## APPLICATION FOR A SPECIAL EXCEPTION

Project Name and Assigned Application Number (SDP, SP or ZMA): Brookhill NMD

ZMA 2015-007

# BROOKHILL SPECIAL EXCEPTION REQUEST

## LANDSCAPE SCREENING EXHIBIT

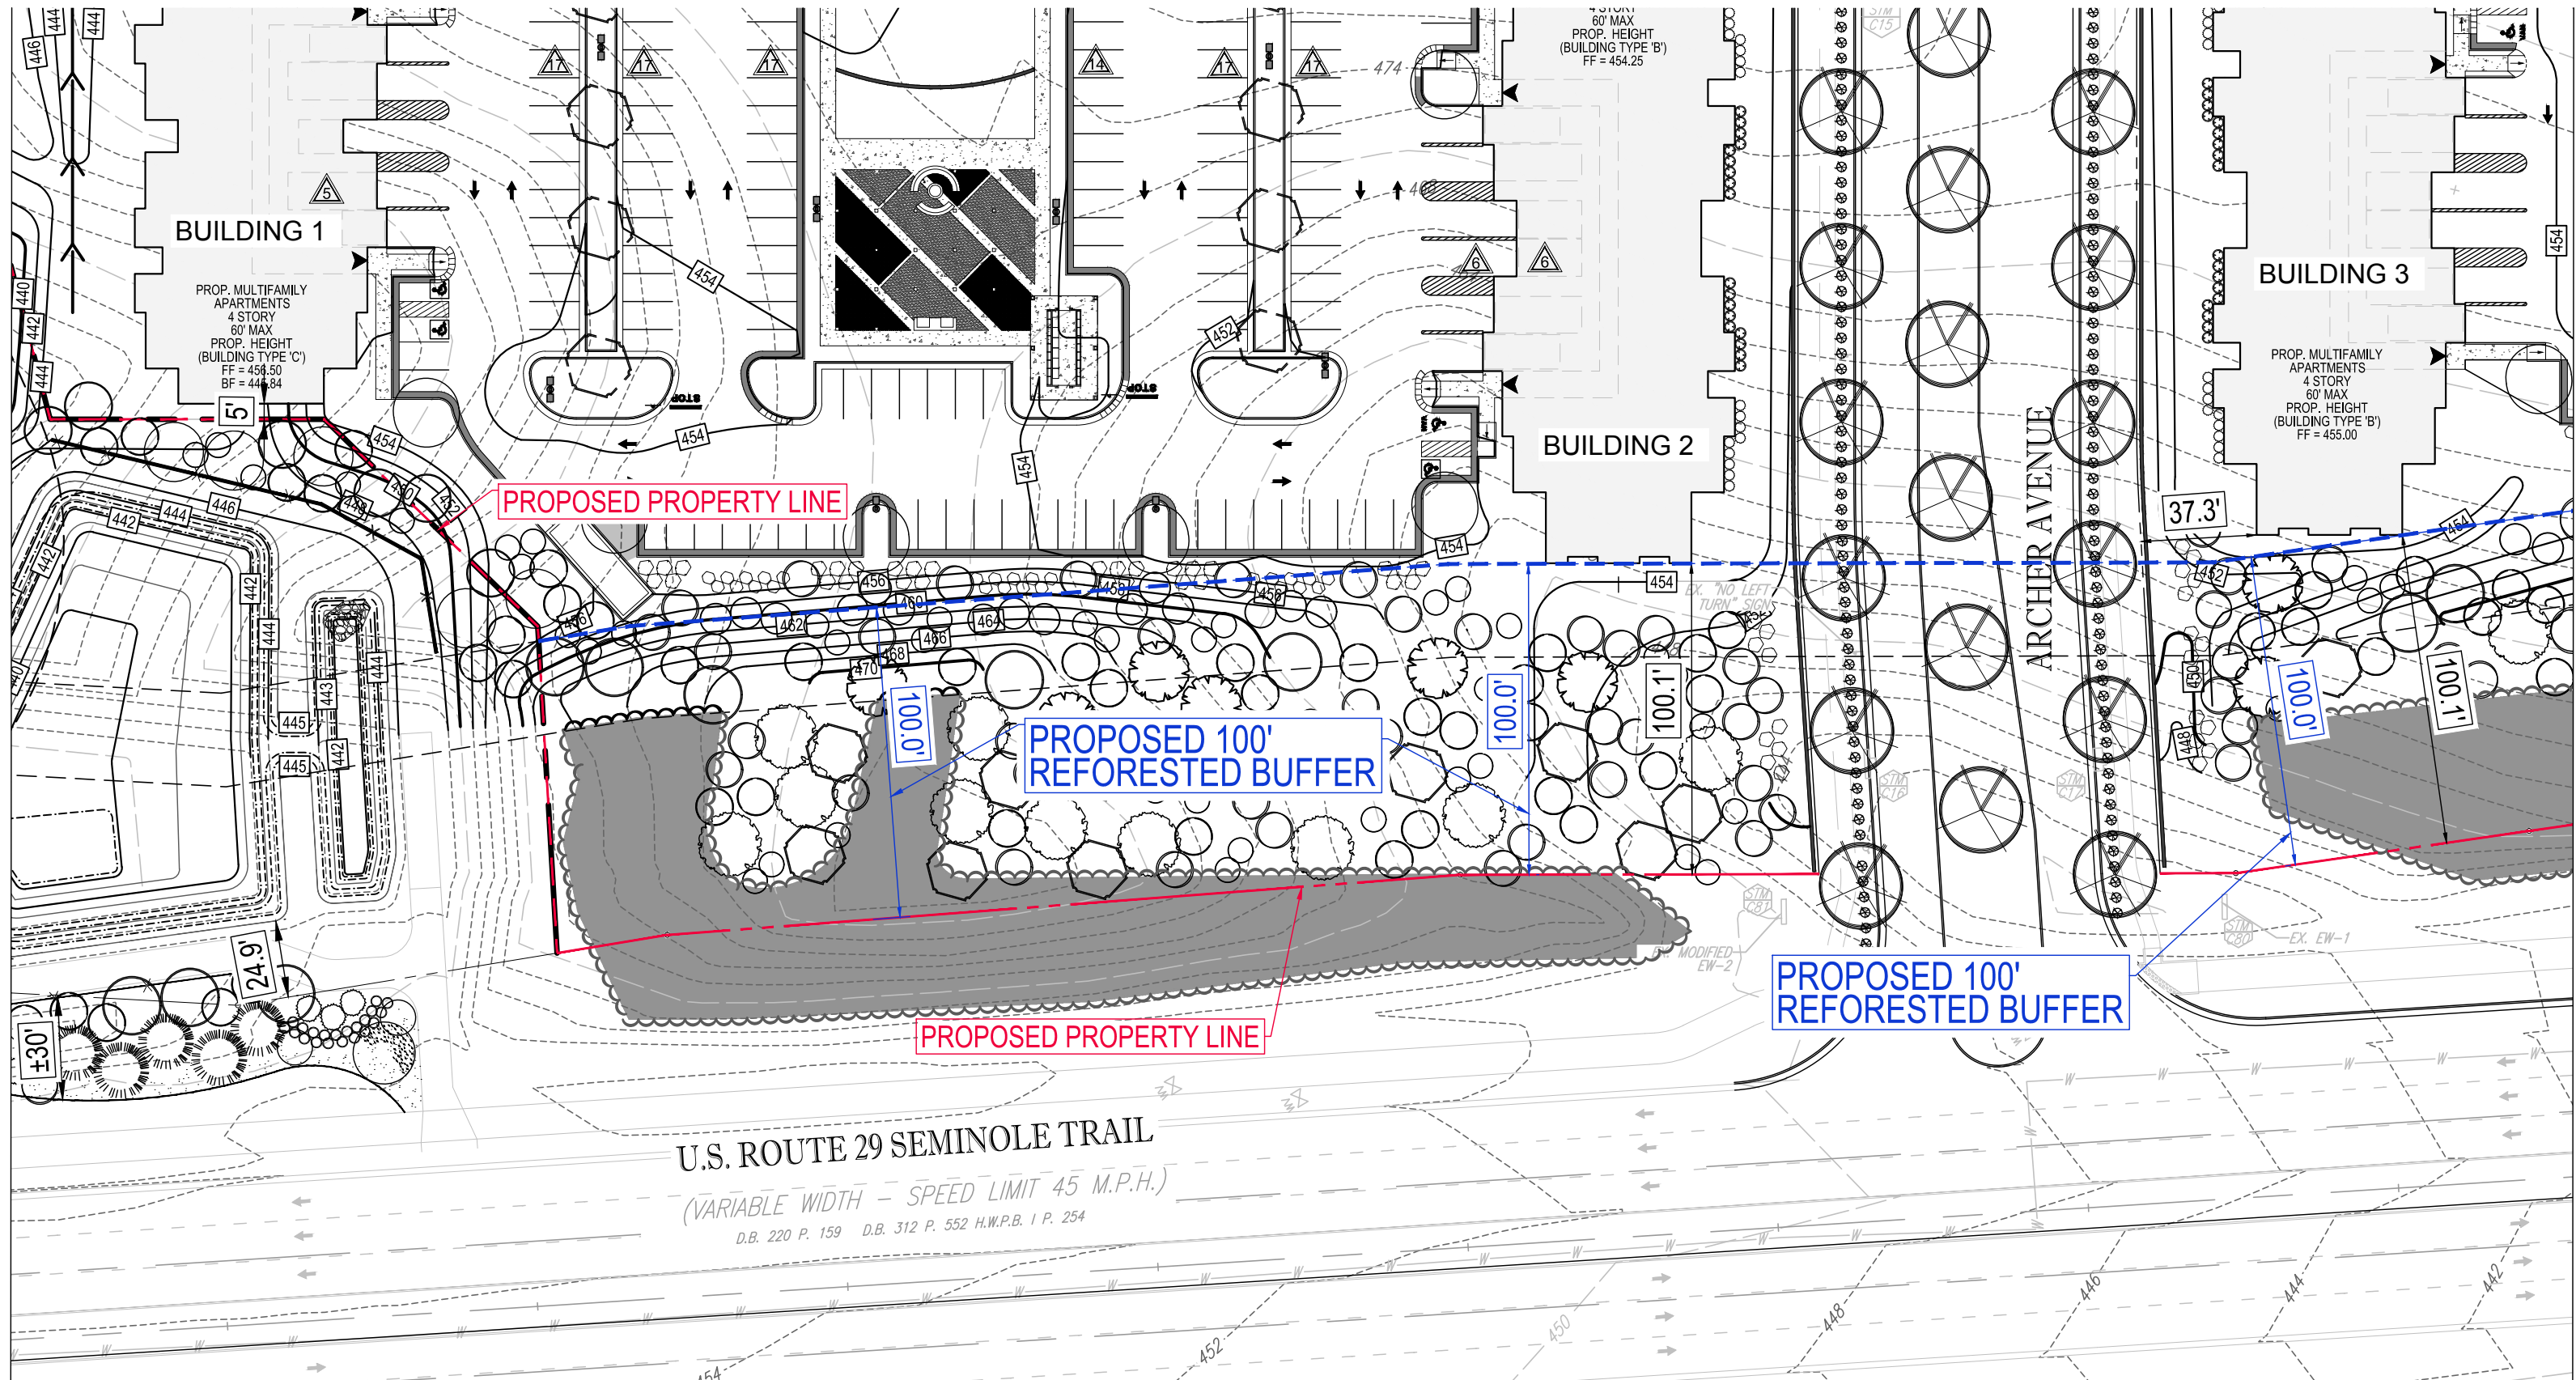
The Applicant has committed to provide 50 feet of buffer area in the vicinity of the Facility, however, due to the expanded size of the Facility, the total 50-foot area is not available in between the Facility and the proposed apartment building. Instead, this requested variation would allow flexibility for the full depth of the Stormwater Facility Buffer to be provided not just in between the Facility and the Development, but also in between the Facility and the Entrance Corridor. The area between the Facility and Route 29 includes land within the VDOT right-of-way, however VDOT has already agreed to allow the plantings as shown on our exhibit and the necessary easement document is underway.

Thus, the 50-foot requirement could be successfully accomplished using both areas. This option creates far superior screening from the Entrance Corridor because both the proposed expanded Facility and the Development will be appropriately screened from view. The attached rendering demonstrates the proposed landscaping of the expanded Facility compared to the existing conditions. The proposal also includes the removal of the existing chain link fence surrounding the Facility and replacement with a more attractive dark metal fence, as preferred by the Architectural Review Board.

We request relief from the 50-foot buffer requirement in between the Facility and the Development in order to provide a solution which splits the buffer area to buffer both the Facility and the Development. The full 50-foot depth of buffering will be accomplished with this request; however, the area in between the Facility and Route 29 will be utilized.

## BROOKHILL - BLOCK 4 APARTMENTS SETBACK EXHIBIT

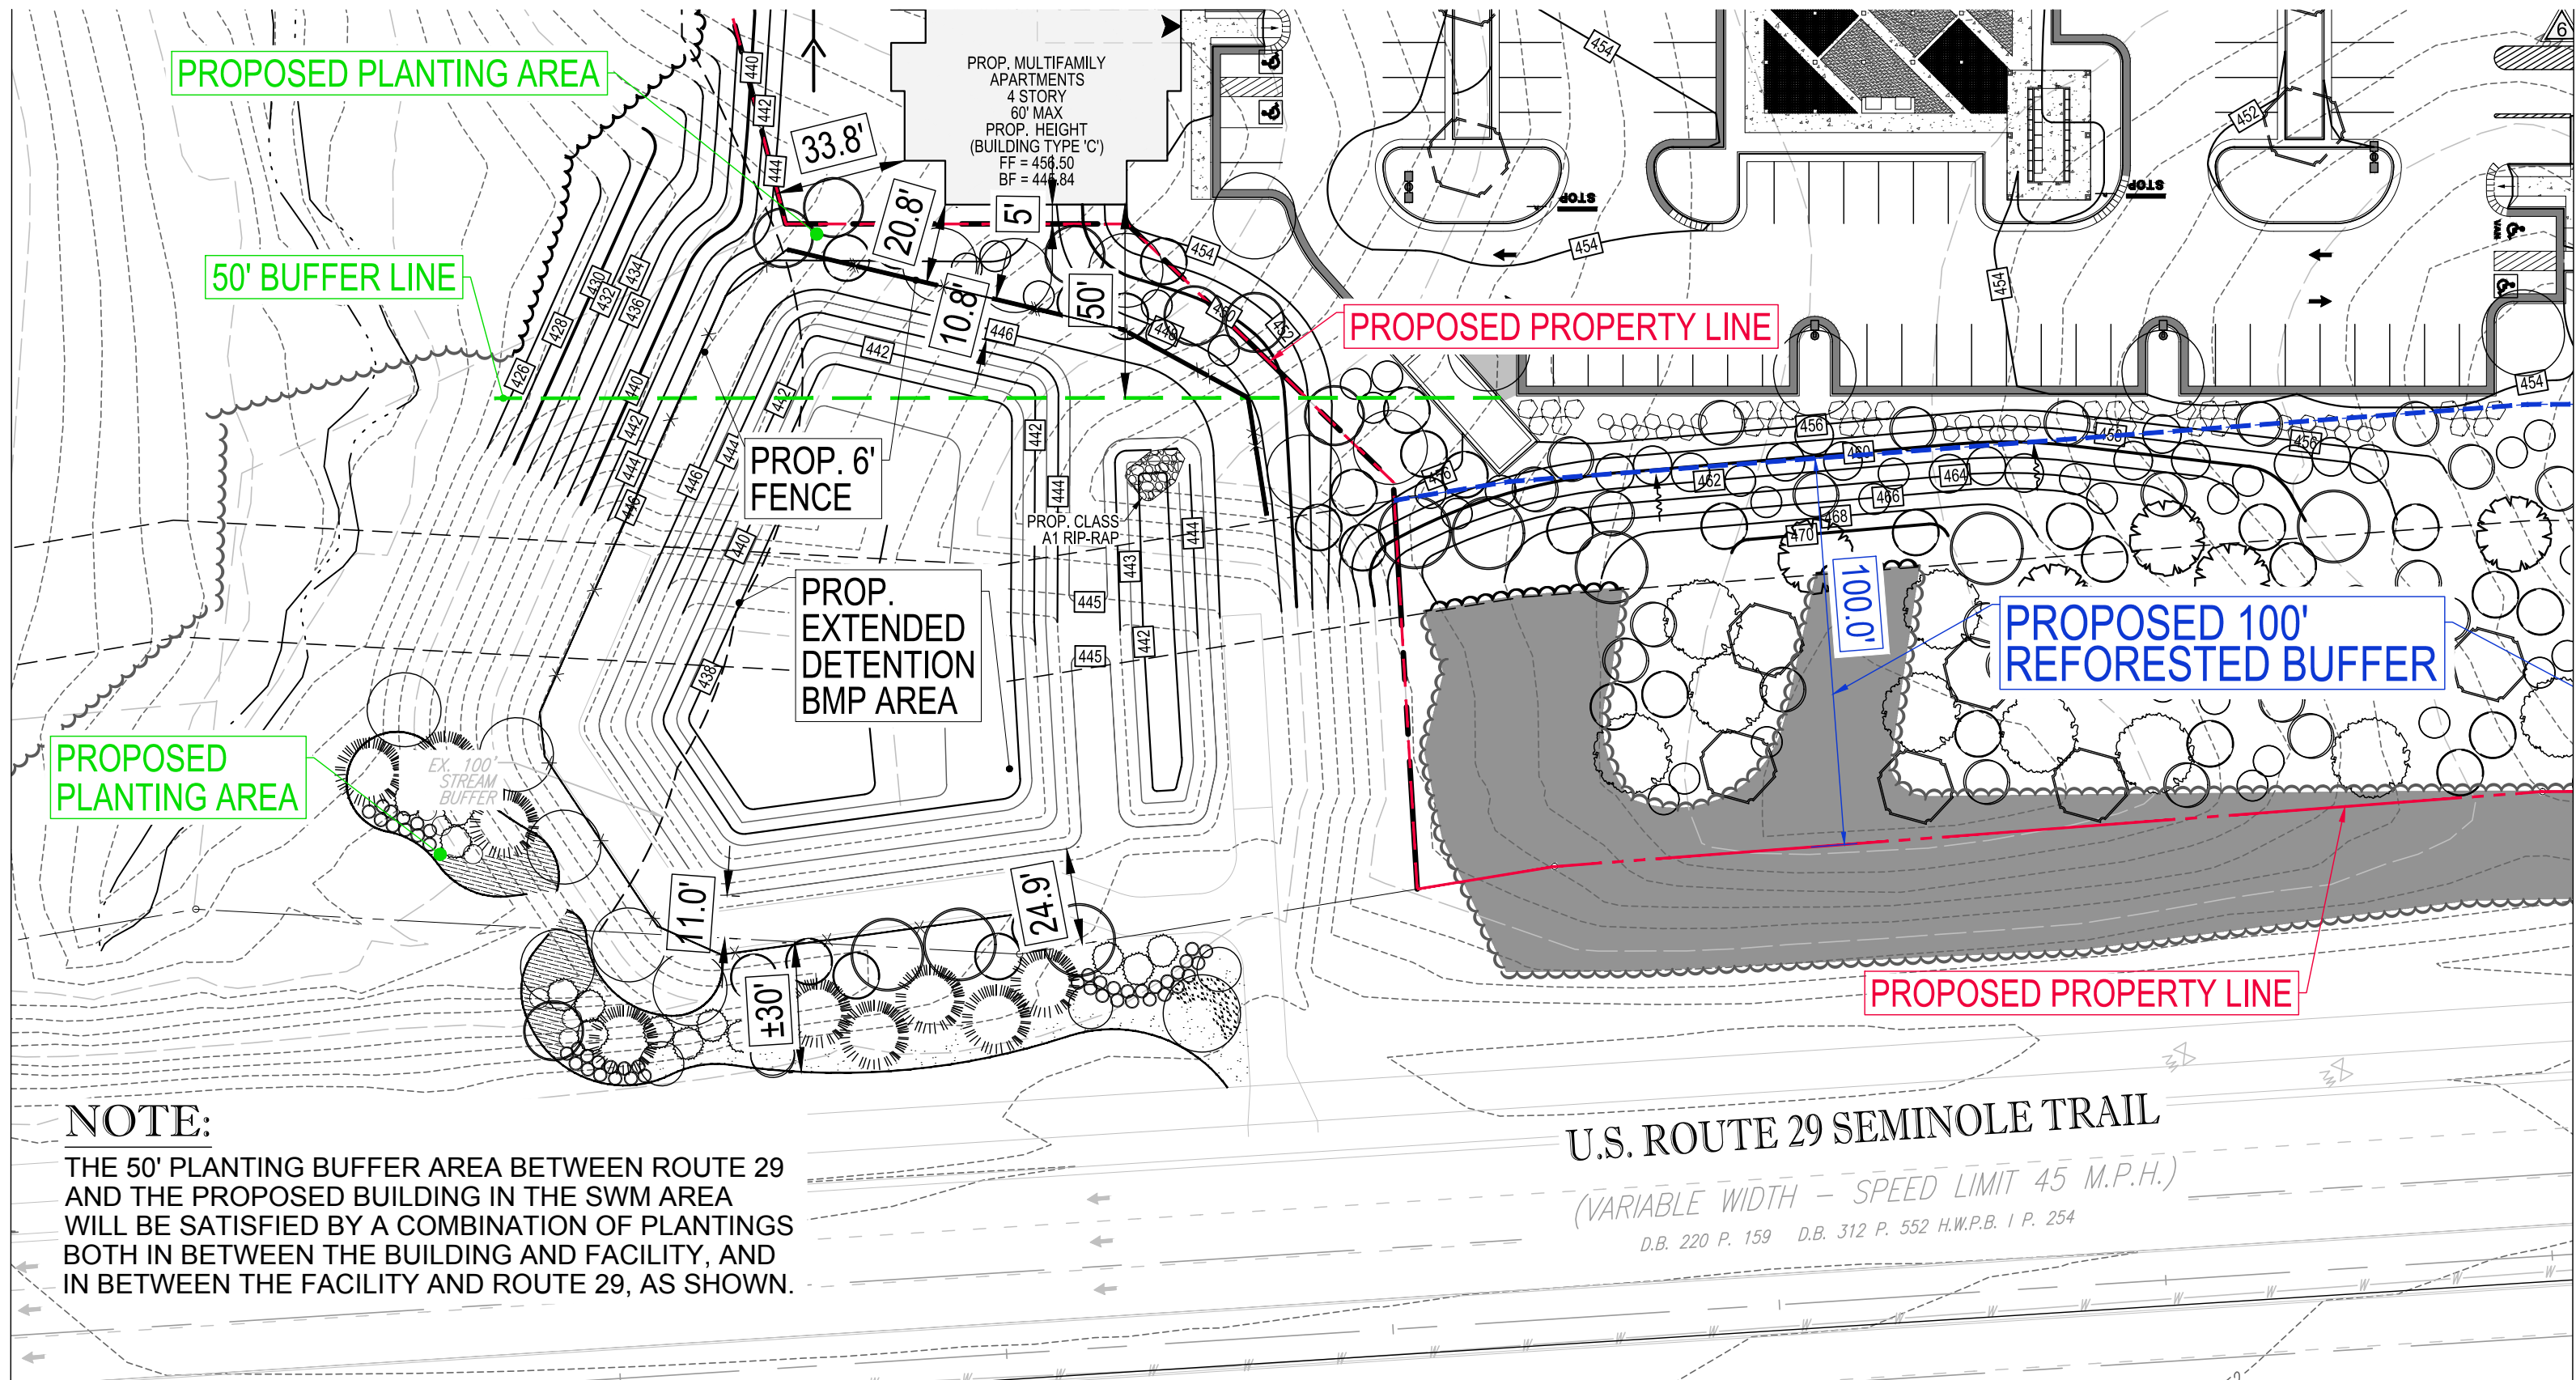
We request relief from the 10-foot minimum rear setback requirement for Block 4 as established on page 17 of the Code of Development in Table 2.3.2.2. The notes section of this table states: "Rear setback for Block 4 shall be adjacent to the Route 29 Buffer". The Application Plan and Code of Development are attached for your reference. As noted previously, the Route 29 Buffer already provides at minimum a 100-foot setback along the Route 29 frontage that will be extensively landscaped due to the Applicant's reforestation efforts.

The Development of Block 4 includes multiple apartment buildings and associated parking and support structures. There are three areas within the Block 4 site plans in which the 10-foot rear setback is not met, as shown in the attached exhibit. We contend that the 100-foot setback established by the Buffer is more than adequate in this case and the addition of 10 feet of setback adjacent to the Buffer is not necessary and does not provide any additional public benefit. Renderings of the proposed Development from Route 29 are also attached, demonstrating the extensive buffer area and providing a simulation of the reforestation efforts of the Applicant.
